# CITY OF LITCHFIELD PARK

## DESIGN REVIEW BOARD

**SUBJECT:** Applications for Review by the Design Review Board (DRB)

The proposed partial south elevation for the addition appears as follows:

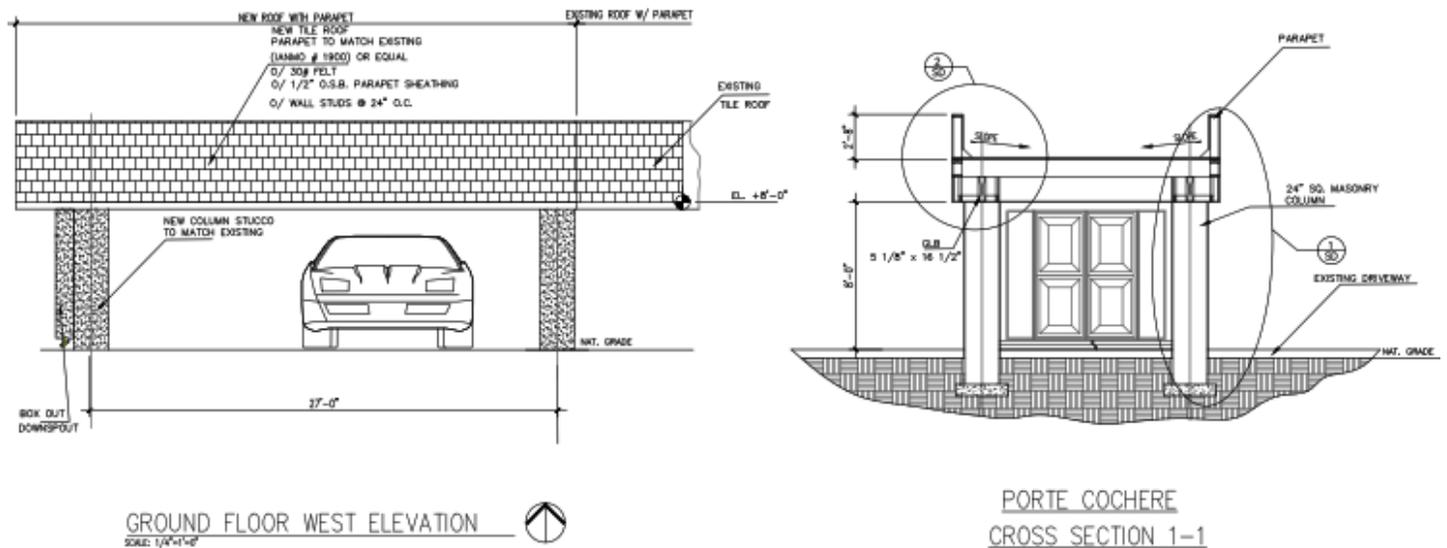
In the partial elevation above existing street view, the new addition includes the new additional two car garage door next two the existing 2-car garage door. It appears that the home will now have a total of 6 garage stalls for vehicles. The new garage addition

will be set back from the existing door and is tucked behind street view from the existing garage. Staff does not anticipate any negative street view impacts of the addition due to its location on the lot and orientation of the home to the street.

Although not specifically noted on the plans, it appears that the architect has attempted to match the stucco finish of the home and match the S-tile concrete roofing material. The proposed garage door also appears to match the existing door in the street view.

- 1) All colors, building materials, and finishes shall match those of the existing residence.
